CONTRACT CHANGE ORDER NO. ____
SHEET ____ OF ____

MARK	DATE	DESCRIPTIONS	BY	CH'D	CCO#
1	04/22/11	W2-OBG SAFETY CABLE	CC	JD	188
0	03/25/11	W2-OBG SAFETY CABLE	CC	JD	188

SAN FRANCISCO OAKLAND BAY BRIDGE
EAST SPAN SEISMIC SAFETY PROJECT
SELF-ANCHORED SUSPENSION BRIDGE
(SUPERSTRUCTURE & TOWER)

CROSSBEAM ACCESS DETAILS NO. 3A

CROSSBEAM SAFETY CABLE ALTERNATE PLAN (WELDED OPTION) (See Note 8)

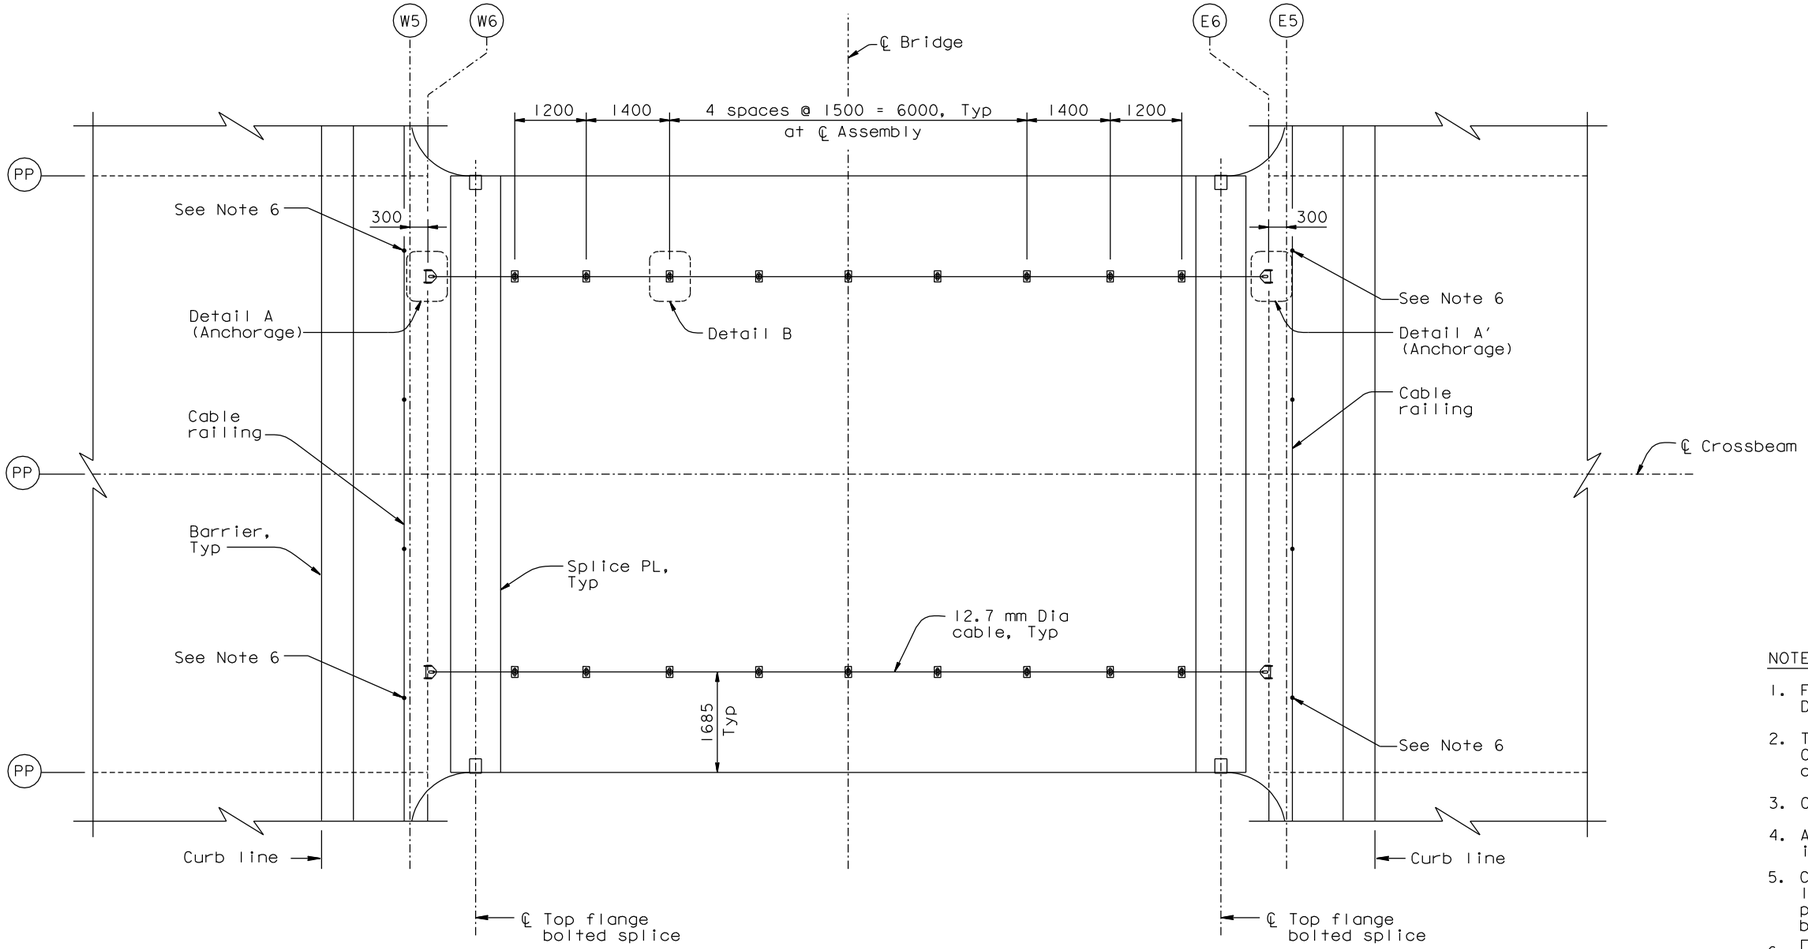
Post this information on a stainless steel plaque (200x300 minimum) on the cable railing posts at the locations shown (4 total). Plaque and mounting details shall be submitted for Engineer's review and approval.
7. For all cable segments, Contractor shall determine installation length by survey.
8. The Contractor may use the welded option or the bolted option. For bolted option, see "Crossbeam Access Details No. 3C" sheet.

CROSSBEAM ACCESS DETAILS NO. 3B

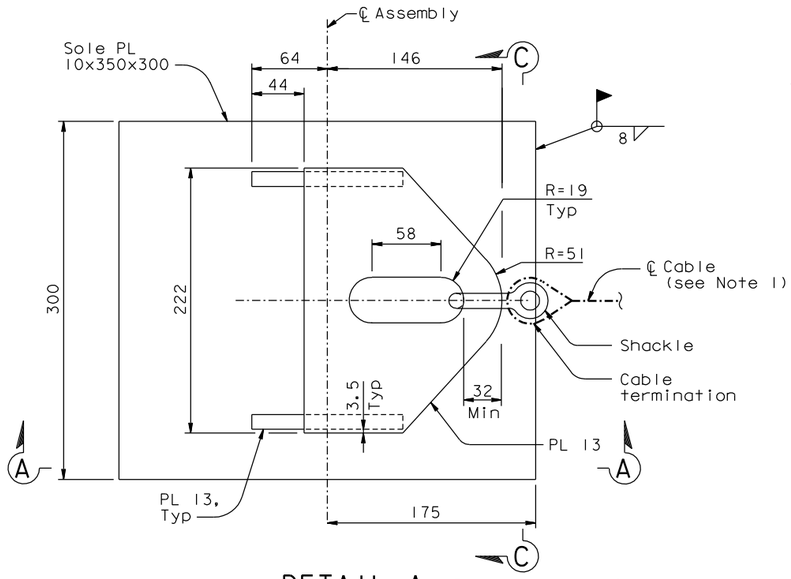
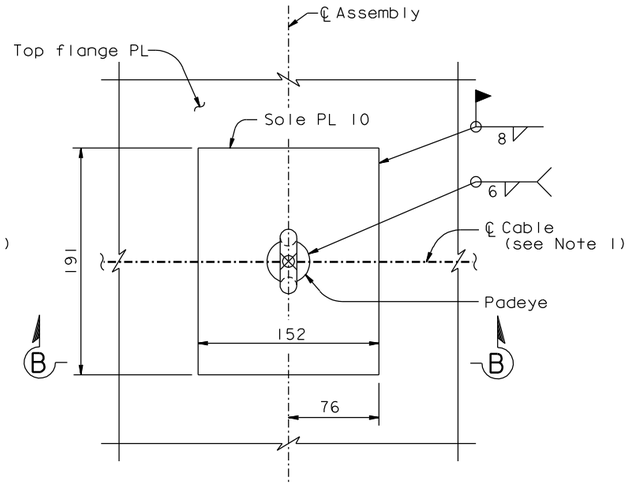
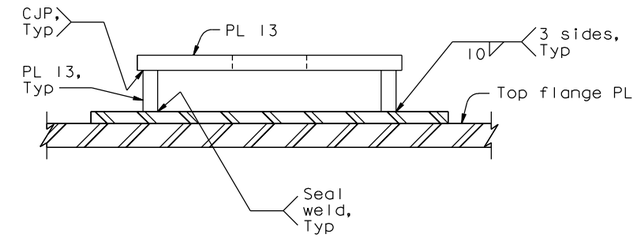
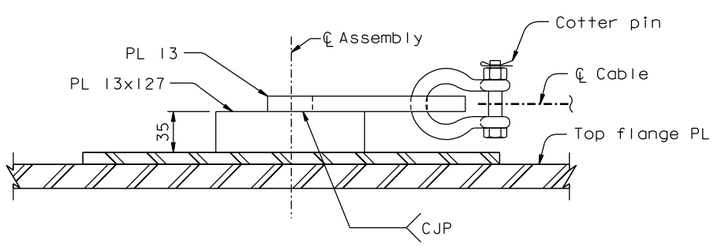
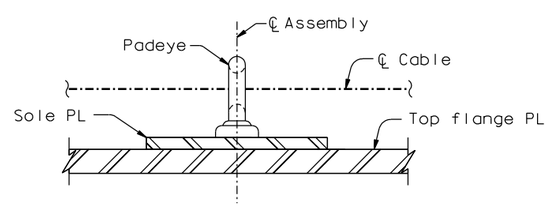
1. For layout of cable, see "Crossbeam Access Details No. 3A" sheet. △1
2. Provide thimbles at all cable loops per manufacturer's recommendations.
3. Padeye shall be Crosby size No.5 or equivalent.
4. Sole plates and anchor plates shall have a minimum yield strength of Fy=50 ksi (345 MPa) and shall be A572 or equivalent.
5. Shackle shall be 0.5 in (12.7 mm) Crosby bolt type anchor shackle or equivalent, with a working load limit of at least 2 metric tons (19.6kN). Shackle shall be galvanized.
6. Assemblies shall be galvanized and painted. △1

MARK	DATE	DESCRIPTIONS	BY	CH'D	CCO#
1	04/22/11	W2-OBG SAFETY CABLE	CC	JD	188
0	03/25/11	W2-OBG SAFETY CABLE	CC	JD	188

CROSSBEAM SAFETY CABLE
ALTERNATE PLAN (BOLTED OPTION)

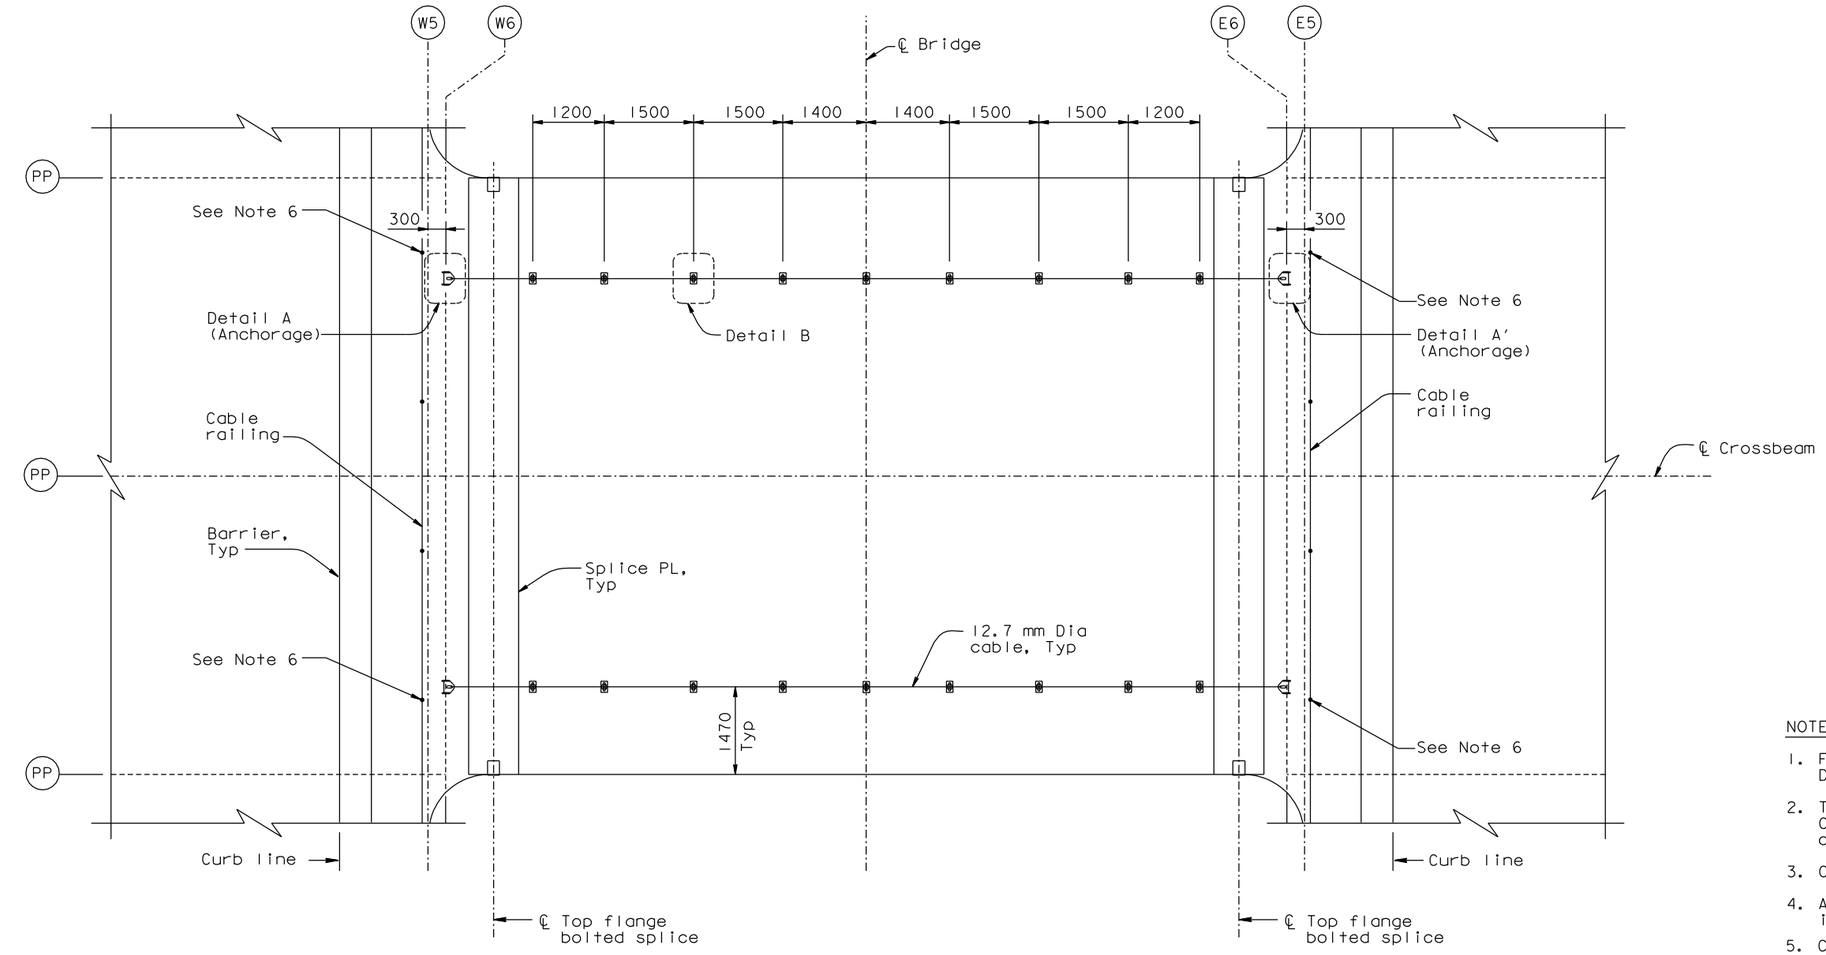
MARK	DATE	DESCRIPTIONS	BY	CH'D	CCO#
0	04/22/11	W2-OBG SAFETY CABLE	CC	JD	188

CROSSBEAM ACCESS DETAILS NO. 3D

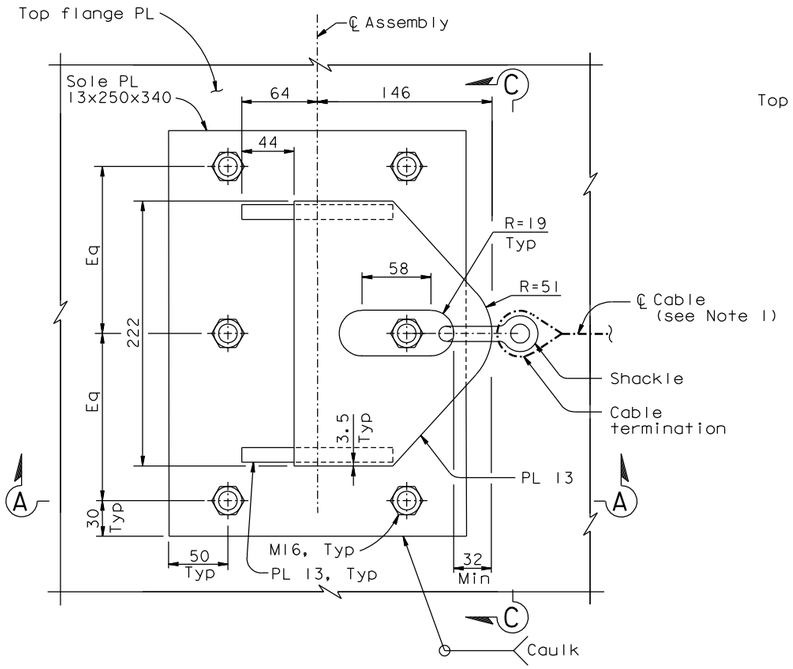
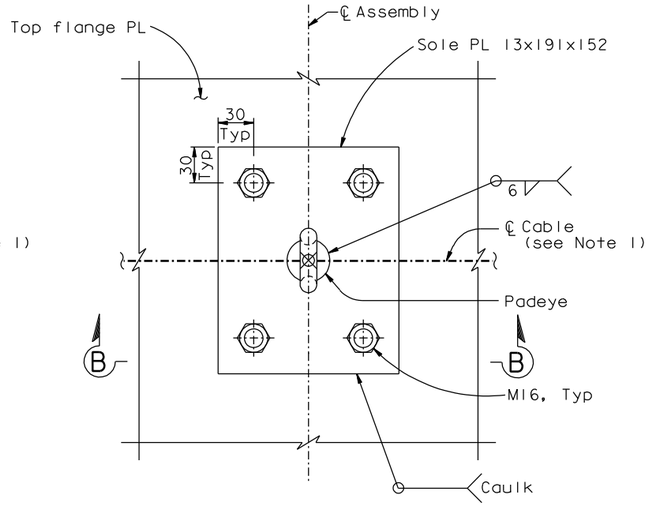
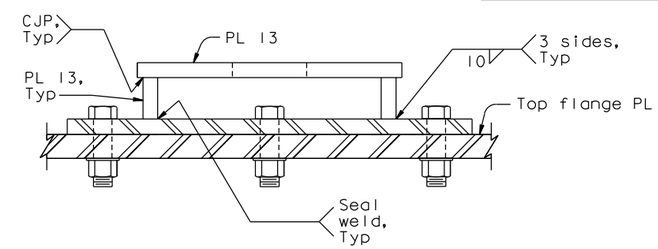
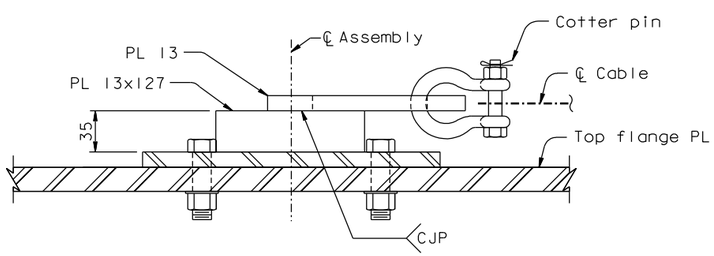
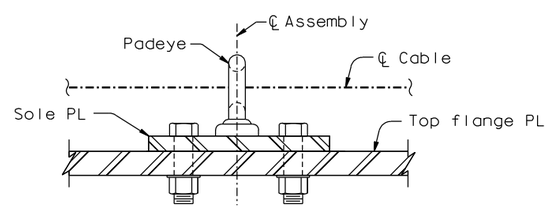
1. For layout of cable, see "Crossbeam Access Details No. 3C" sheet.
2. Provide thimbles at all cable loops per manufacturer's recommendations.
3. Padeye shall be Crosby size No. 5 or equivalent.
4. Sole plates and anchor plates shall have a minimum yield strength of Fy=50 ksi (345 MPa) and shall be A572 or equivalent.
5. Shackle shall be 0.5 in (12.7 mm) Crosby bolt type anchor shackle or equivalent, with a working load limit of at least 2 metric tons (19.6kN). Shackle shall be galvanized.
6. Assemblies shall be galvanized and painted. Class B faying surfaces are not required between sole PL 13 and crossbeam top flange PL.
7. At the Contractor's option, 5/8 inch Dia HS bolts may be used in lieu of M16 bolts.

MARK	DATE	DESCRIPTIONS	BY	CH'D	CCO#
0	04/22/11	W2-OBG SAFETY CABLE	CC	JD	188
